Floyd's Register of Shipping.

I beg to acknowledge receipt of your letter "H" of the 29th Ult^o regarding the Steamer "MOUNT ATHOS" together with sheet showing the original scantlings of this vessel.

A./- Verification of shell plating.

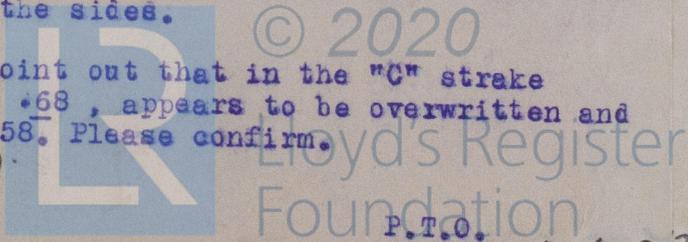
From original scantling sheet sent to me, I understand that where the plating will be found locally wasted, the minimum thickness accepted by Rule requirements should be as follows:-

For Plates: Original thickness: .62.- Minimum thickness: .58. (Bottom and sides.)

For Plates: Original thickness: .44.- Minimum thickness: Bottom: .43

For Plates: ----- d^o -----: Sides : .42

No requirements seems to be given regarding plates of .58 thickness

It is quite possible that I have misunderstood the reading of the scantlings, and I shall be glad if you will be good enough to give me your enlightenments, particularly regarding the minimum limit thickness allowed for plates of .62.- .58.- .44. as well for the bottom as for the sides.

Further, I have to point out that in the "C" strake after end, the figure given as .68, appears to be overwritten and I presume it is meant to be .58. Please confirm.
(as for the other strakes).
